NED-83-325

NRC DOCKETS 50-321, 50-366
OPERATING LICENSES DPR-57, NPF-5
EDWIN I. HATCH NUCLEAR PLANT UNITS 1, 2
PURGE AND VENT VALVE OPERABILITY
SCHEDULE OF RESOLUTION

PURGE AND VENT SYSTEM

OPERABILITY

FIGURE 6.2-25

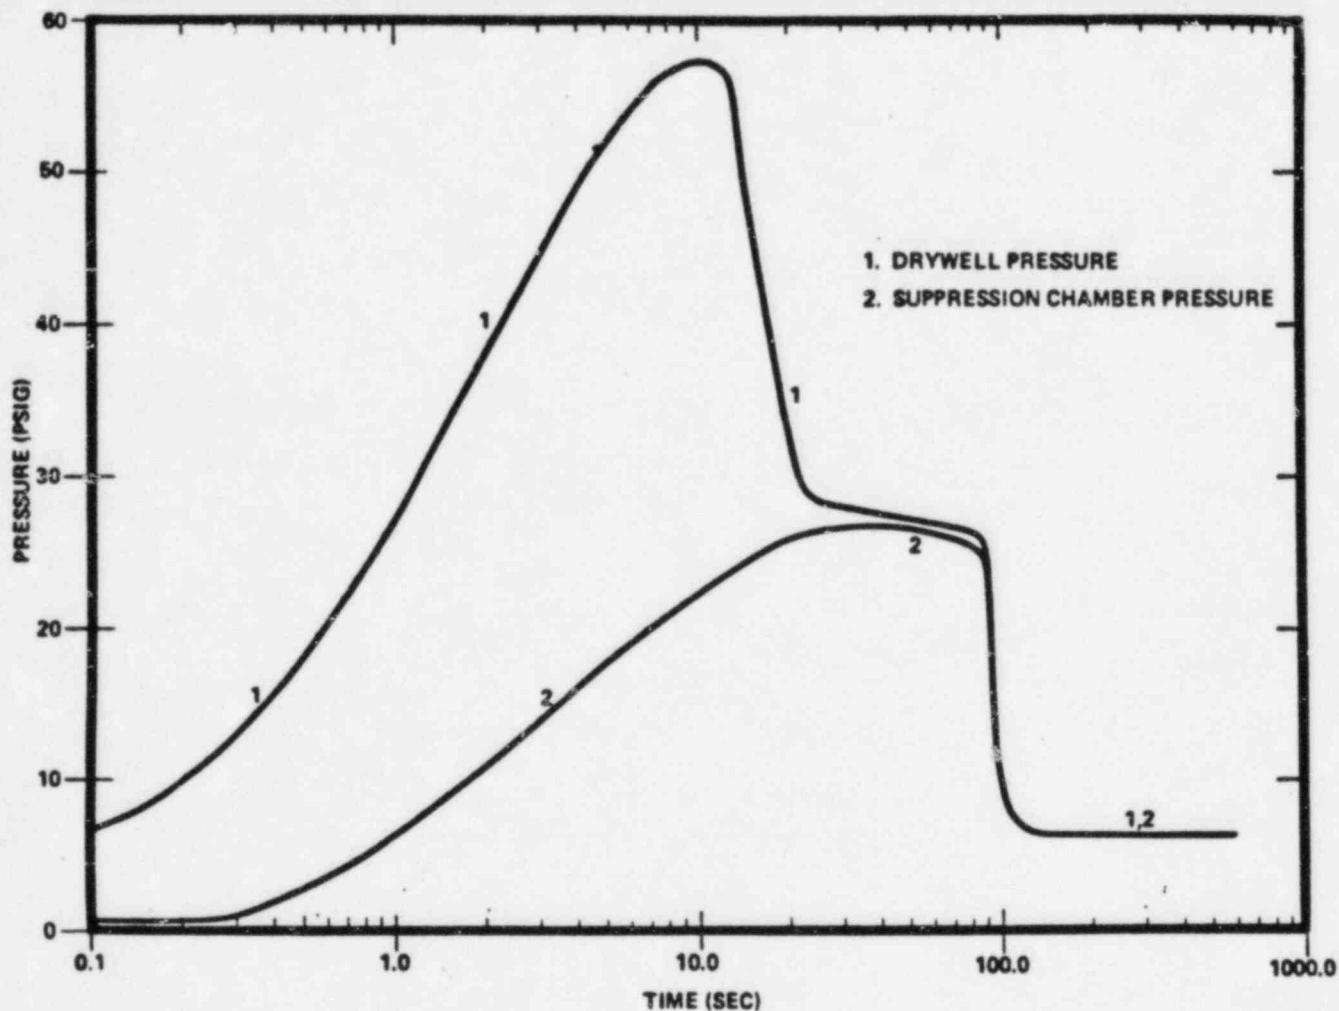
Valve assembly 2T48-F318 cannot be rotated into a shaft-elbow inplane configuration. Therefore, in the out of plane configuration a safety factor of 3 is used. With this safety factor the disc must start to move at a ΔP of 20 psi. Using figure 6.2-25 curve 2 for the torus from the Unit 2 FSAR, attached, it can be seen that a ΔP of 20 psi occurs at 7 seconds.

The plant Technical Specifications require valve closure within 5 seconds. The valve will be fully closed prior to reaching a ΔP of 20 psi. Therefore, it is concluded that valve motion will be initiated far before it is required.
